## FIELD SERVICE CAMPAIGN – 21104

14 July 2021

Vertical Stack Slider Pivot Support

International® HX® Series Trucks with International® A26 or Cummins® X15 engines.

**Figure 1. Pivot Support Assembly**

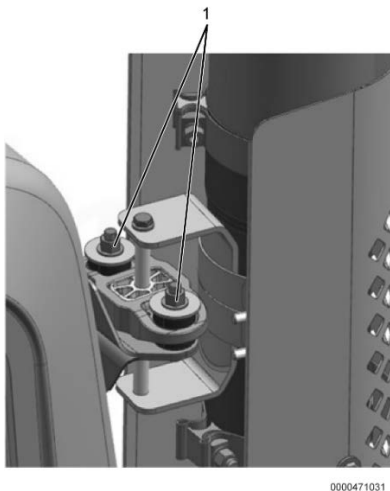
5. Remove pivot support mount nuts and washers (Figure 1, Item 1).

19. Install exhaust clamp (Figure 2, Item 3). Using a torque wrench, tighten nut to 8 lb-ft (10.84 N•m).
  20. Install pivot support mount nuts and washers (Figure 1, Item 1). Using a torque wrench, tighten nuts to 30 lb-ft (40.67 N•m).

**Figure 2. U-Bolt Clamp and Exhaust Clamp**

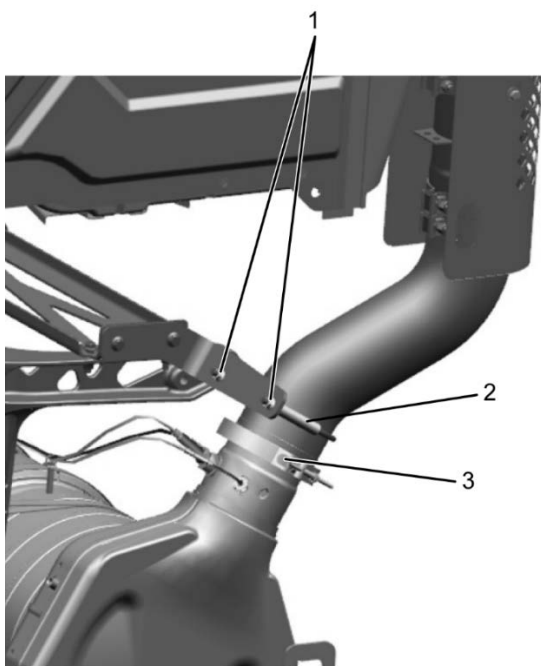
1. U-bolt nut (2)
  2. U-bolt clamp
  3. Exhaust clamp
6. Remove exhaust clamp (Figure 2, Item 3).
7. Remove both U-bolt nuts (Figure 2, Item 1) and U-bolt clamp (Figure 2, Item 2).

16. Install vertical stack to aftertreatment, install pivot support assembly (Figure 3, Item 1) and mounts to support studs (Figure 3, Item 2).
  18. Install U-bolt clamp (Figure 2, Item 2) and both U-bolt nuts (Figure 2, Item 1). Using a torque wrench, tighten U-bolt nuts to 28 lb-ft (37.96 N•m).

**Figure 3. Support Assembly (Heat Shield Not Shown for Clarity)**

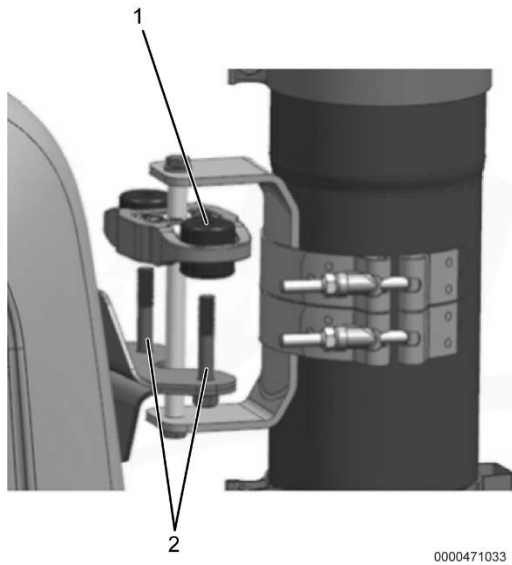
8. Slide up pivot support assembly and mounts (Figure 3, Item 1).
9. Remove vertical stack assembly and S-pipe from aftertreatment.

**Figure 4. Vertical Stack Rod**

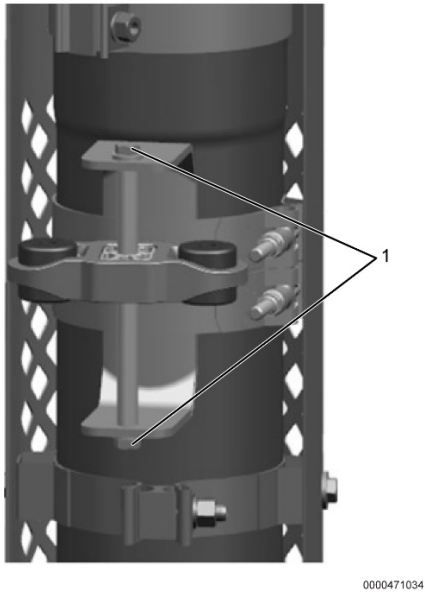
1. Rod bolt (2)
10. Remove both rod bolts (Figure 4, Item 1).
11. Remove rod from pivot support.

13. Install new pivot support in pivot support assembly.
  14. Install rod in pivot support.
  15. Install rod bolts (Figure 4, Item 1). Using a torque wrench, tighten rod bolts to 24 lb-ft (32.53 N•m).

**Figure 5. Pivot Support Assembly**

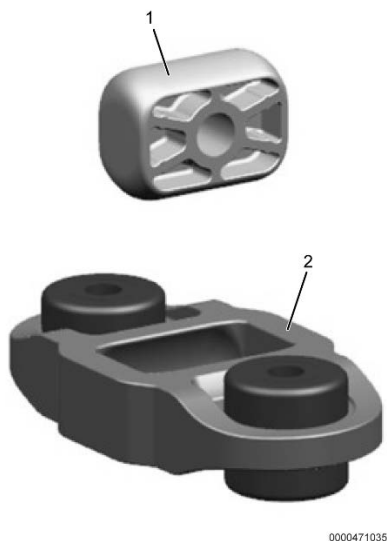
Certain International® HX® Series trucks with International® A26 or Cummins® X15 engines may have been built with an undersized exhaust slider isolator resulting in premature wear of the isolator and increased noise.

1. Pivot support
  2. Pivot support assembly
12. Rotate pivot support 90 degrees (Figure 5, Item 1) and remove pivot support assembly (Figure 5, Item 2).
